Subject: PW11.1 - Gardiner Expressway and Lake Shore Boulevard East Reconfiguration Environmental Assessment (EA) and Integrated Urban Design Study - Evaluation of Preferred Design

Maintaining Cycling Connections During Gardiner East Reconstruction.

Image of Option 1, Pre-Stage construction phasing map indicating Villiers Street as a 6-lane detour route:

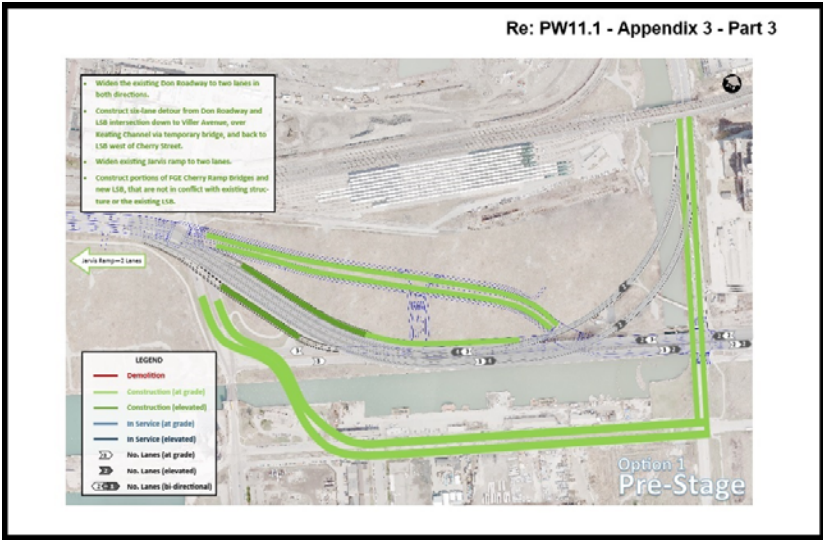
In the construction phasing plans developed by Dillon Consulting (PW11.1, Appendix 3 - Part 3 - Alternative Designs Evaluation Report, Dillon Consulting, February 2016 - (<http://www.toronto.ca/legdocs/mmis/2016/pw/bgrd/backgroundfile-90627.pdf>) - a note at the top left of the construction phasing map titled "Option 1 Pre-Stage" (page 1 of 4) - indicates a detour from the Don Valley Parkway to the Gardiner Expressway and Lake Shore Boulevard, where I note that Villiers St is to be used as a detour that will maintain a 6-lane connection between the Don Valley Parkway to the Gardiner Expressway and Lake Shore Boulevard.

In the text box top left, second bullet point: "**Construct six-lane detour from Don Roadway and LSB intersection down to Villiers Avenue, over Keating Channel via temporary bridge, and back to LSB west of Cherry Street.**"

I encourage PWIC require that the consultants report back to PWIC, on a way to keep this important recreational and commute cycling route open during all phases of the construction; and as well, make sure that cyclist construction detouring around the Gardiner East reconstruction is well signed and follows the safest and most direct route possible with signage and road markings where appropriate.

Preferred Route of Lower Don Recreation Trail Detour around Gardiner East rebuild

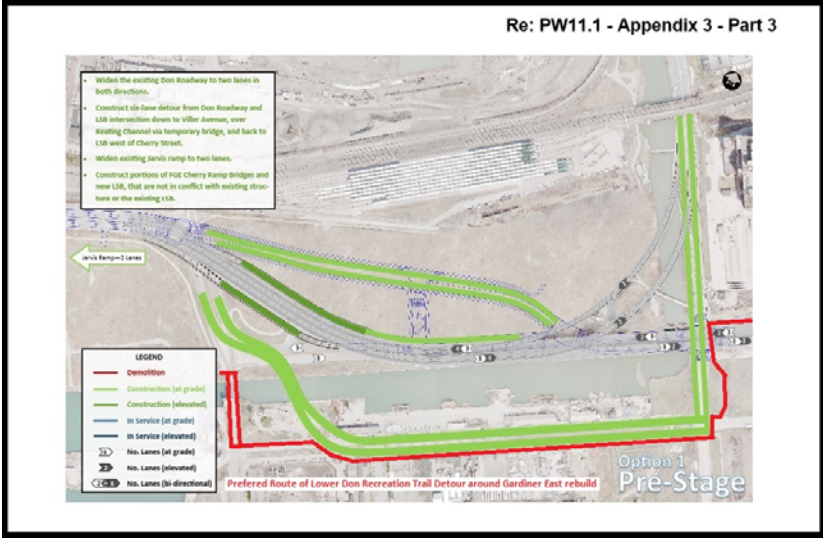
I suggest that the most direct route (one that will encourage commute cycling) is the installation of a Multi-use Path along the south side of the 6-lane detour along Villiers - until the point where the detour begins to swing north to the temporary bridge across the Keating Channel - where the Bike route would then continue west on Villiers Street to Cherry Street and north of Cherry to the beginning of the Martin Goodman Trail just north of the Keating Channel Lift Bridge (Bascule Bridge).

Gardiner East re-construction phasing map markup indicating Multi-use Path detour route on the south side of Villiers Street
